Re: 0 Mountain Road – revised plans

Please see the following in response to comments made by the consultant and commissioners at the February 22, 2024 Wetlands Commission meeting and the Engineering department's letter dated February 7, 2024.

0 MOUNTAIN ROAD RIGHT OF WAY

FCE #2168

OLD DRIFTWAY LLC	
0 MOUNTAIN ROAD	WILTON, CONNECTICUT
ALTERNATE CROSSING	
CIVIL ENGINEERS	2168 project
FAIRFIELD COUNTY ENGINEERING L.L.C.	
7 OF 7 sheet

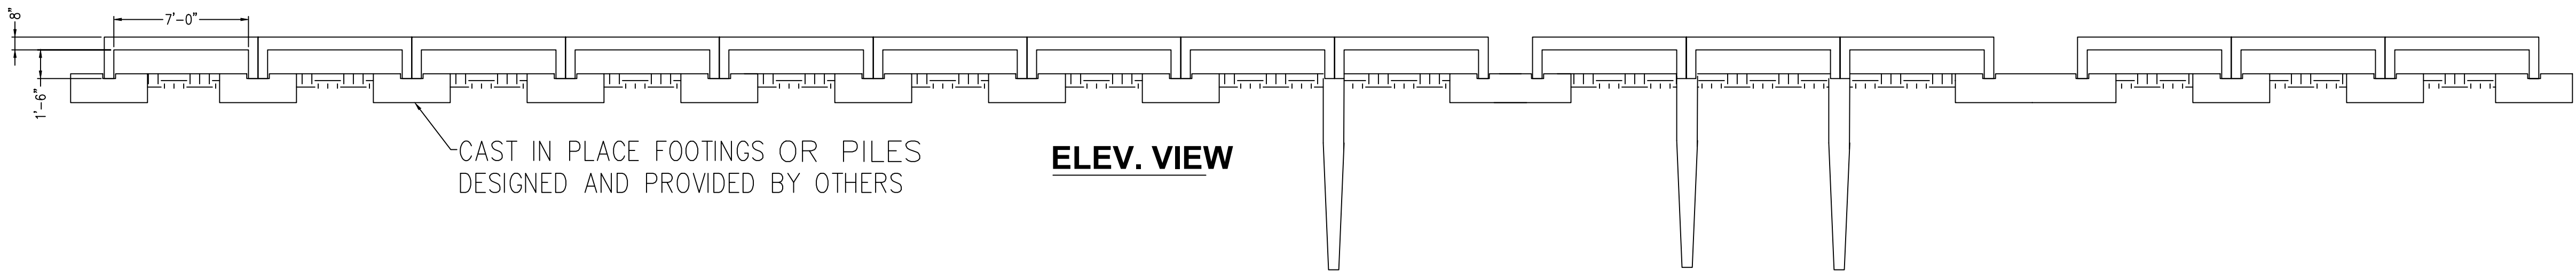
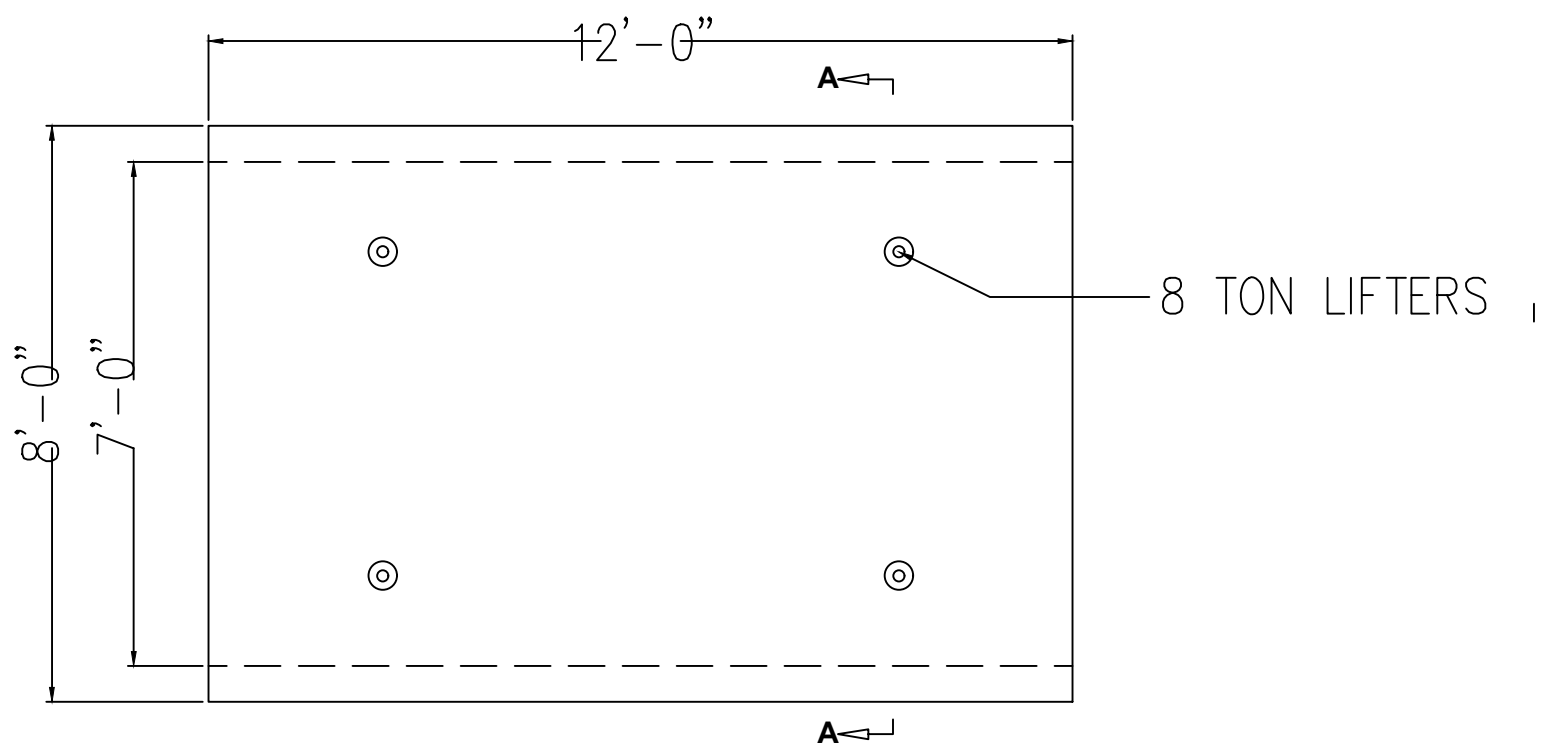
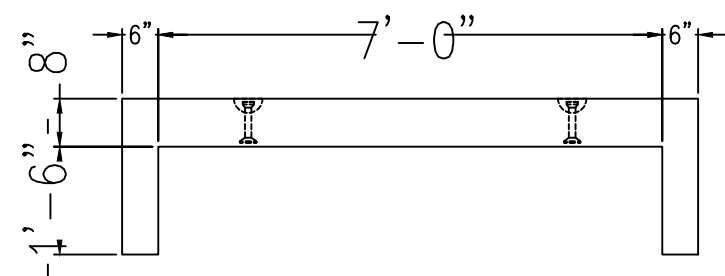
We have suggested as an alternative a 3 sided box culvert, which would be open on the bottom and allow the native soil to remain in that area. These are essentially the same precast units flipped without the top section. They are also HL 93 rated and weigh less (13,000 pounds), so installation with a mini excavator will not be an issue.

This alternative will require a footing. Depending on the soil bearing capacity test results, this will either be spread footings, formed and poured, or piles, either the conventional driven piles or helical piles. The helical piles would be the better choice of pile type, as it would afford the least disturbance in the wetland area during construction.

Regardless of the soil bearing capacity results, piles will be a viable option to provide support to the culverts. Piles are driven to resistance (bedrock), which will support the loads. It is likely bedrock (ledge) will be encountered on this site to support the piles. If bedrock should not be found, they are driven to a sufficient depth for the friction resistance and point resistance to provide the support. Piles are often used in completely submerged situations as footings for bridges, etc., with poor silty or clay soil.

This alternative will likely provide less long term impact on the wetlands than the four sided box culverts. The short term impact may be greater than the four sided box culvert, but still far less than that of a bridge.

OLD DRIFTWAY LLC	
O MOUNTAIN ROAD WILTON, CONNECTICUT	
RIGHT OF WAY PLAN WETLANDS CLOSEUP	
CIVIL ENGINEERS	2168 project
4 OF 7 sheet

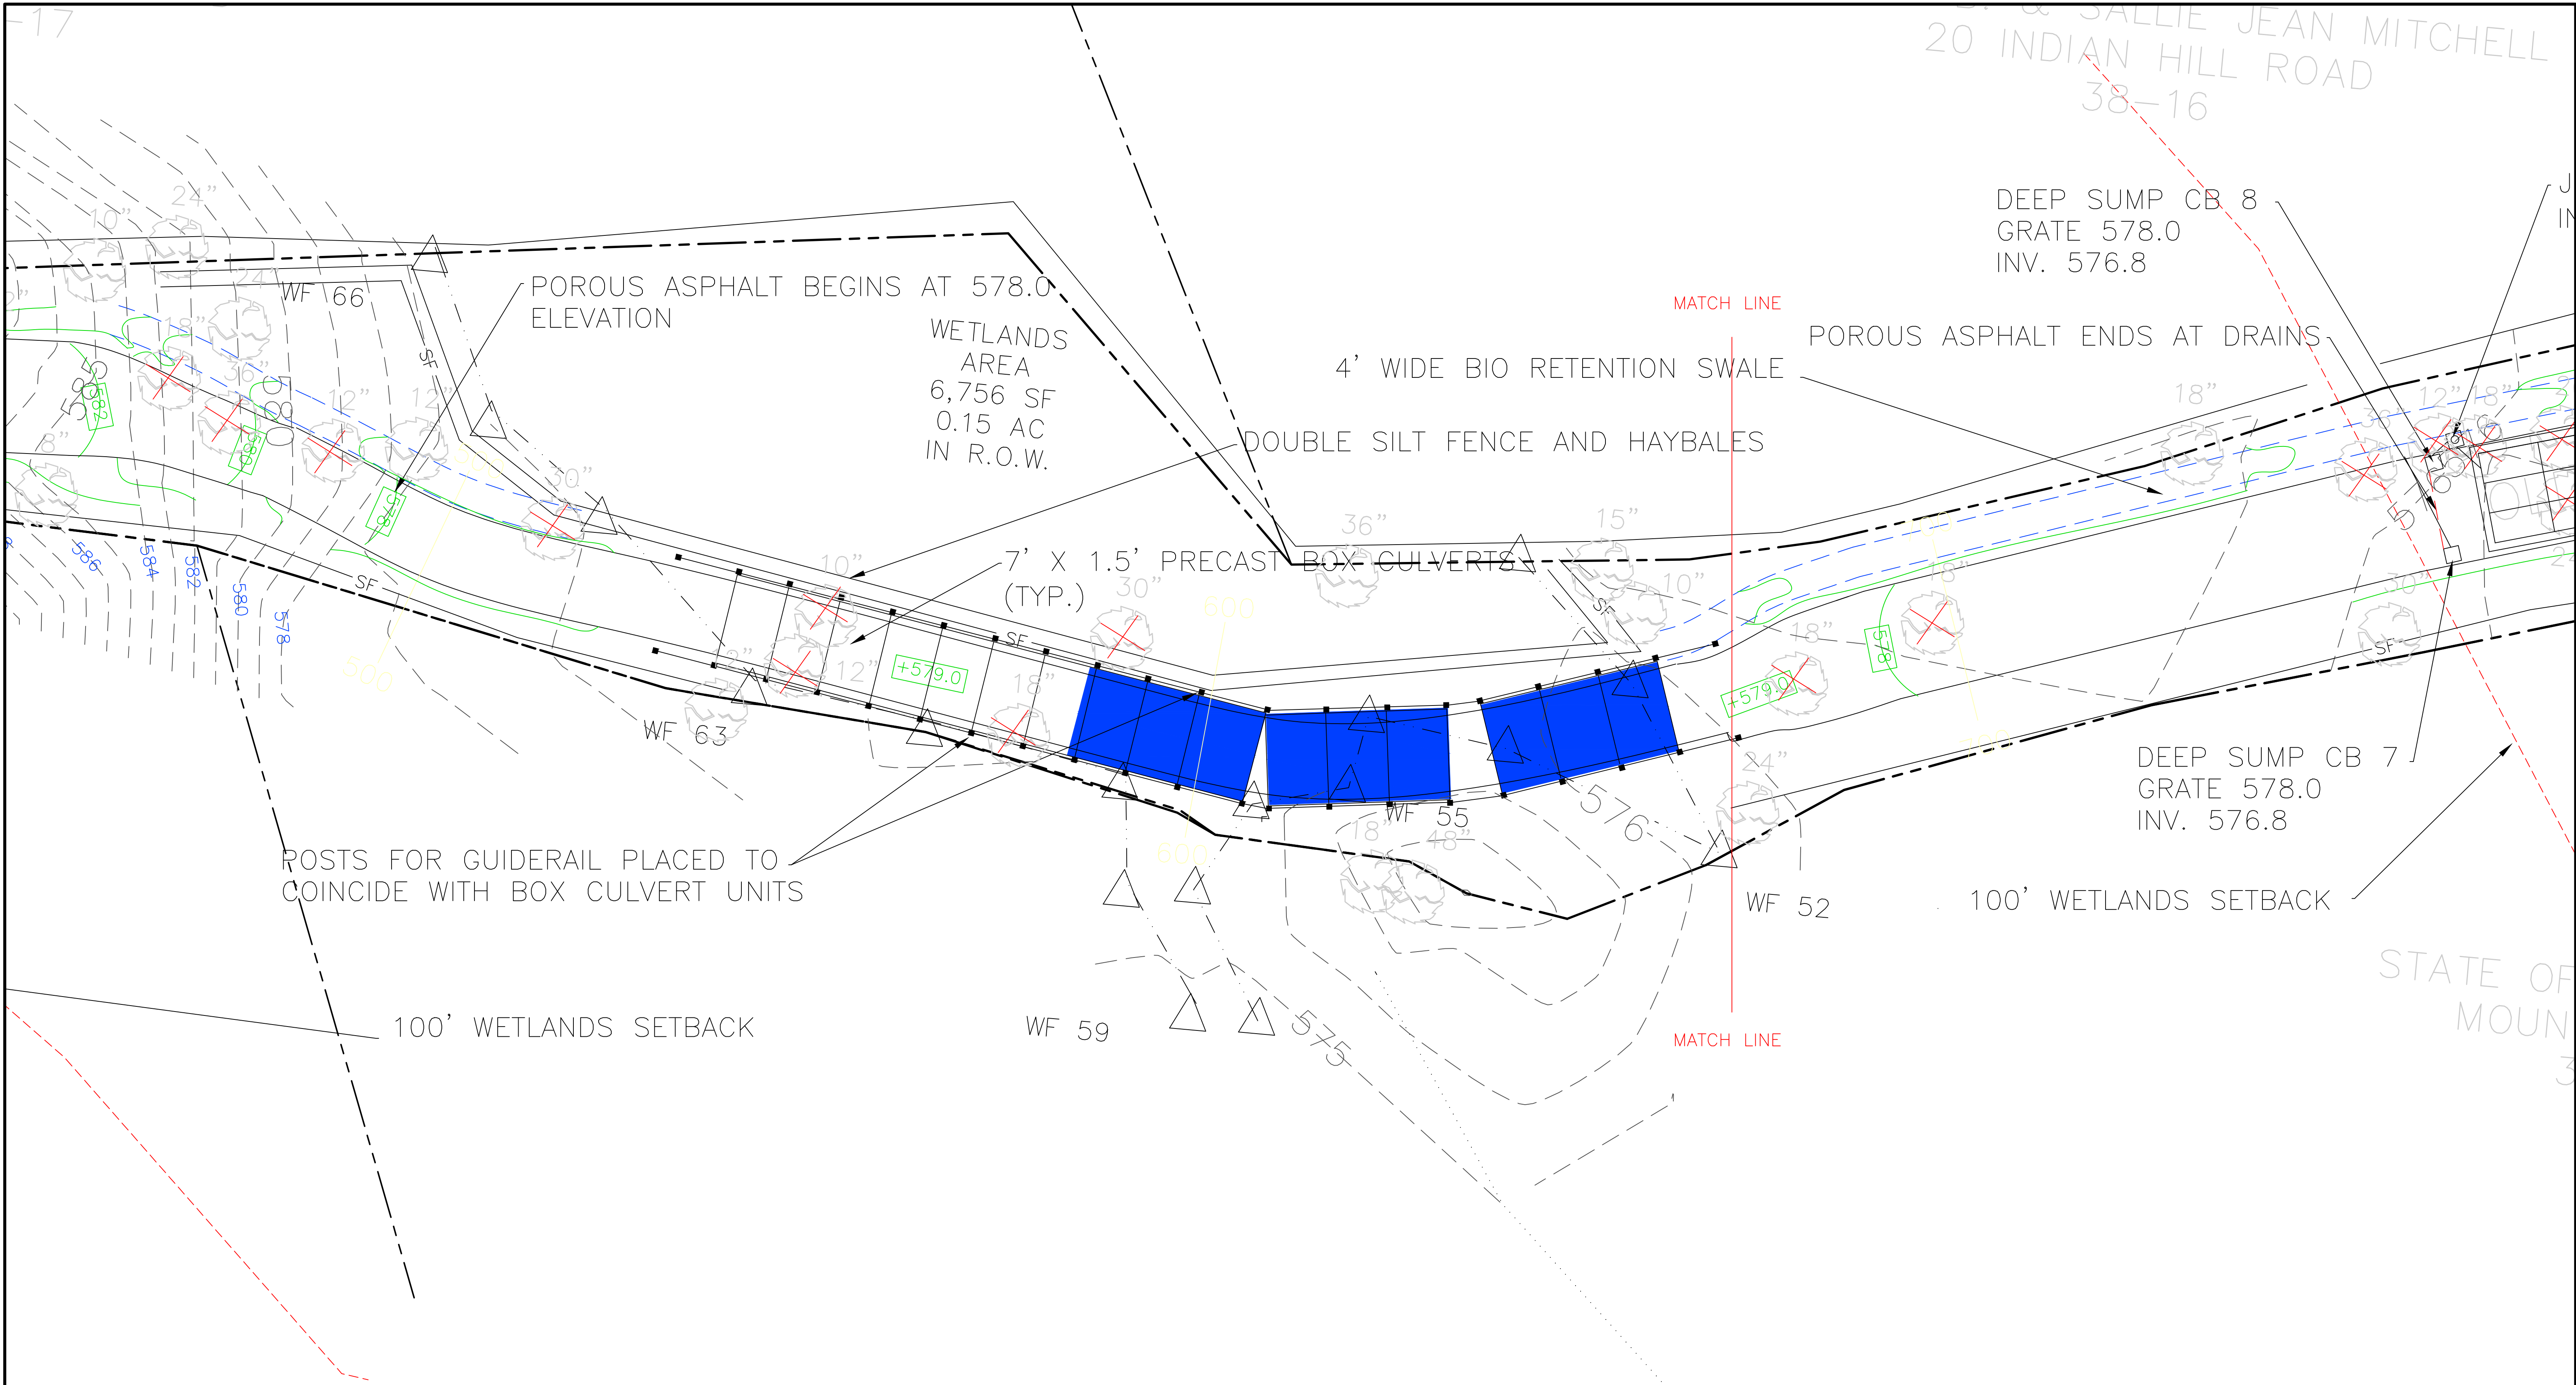
11. Two drains and a gallery were added at the lower portion (entry) of the driveway to capture and attenuate the runoff. This additional retention is not even counted as credit in the total runoff reduction calculations.

13. The galleries are primarily in a cut in the lower portion of the driveway where the accessway is narrowest, and thus are not raised, reducing the danger of bleedout.

14. The recent soil tests *in the specific area of each gallery set* confirm there will be adequate separation to ledge; the galleries will infiltrate and drain adequately. A comment was made regarding one hole in the gallery that will be in a fill area. If, as an example, ledge was discovered 4 feet below the existing grade at that point, and the galleries will be in a raised area of 2 feet of fill, then the ledge will be *6 feet below finish grade*, providing *more* separation. Again, this is common sense.
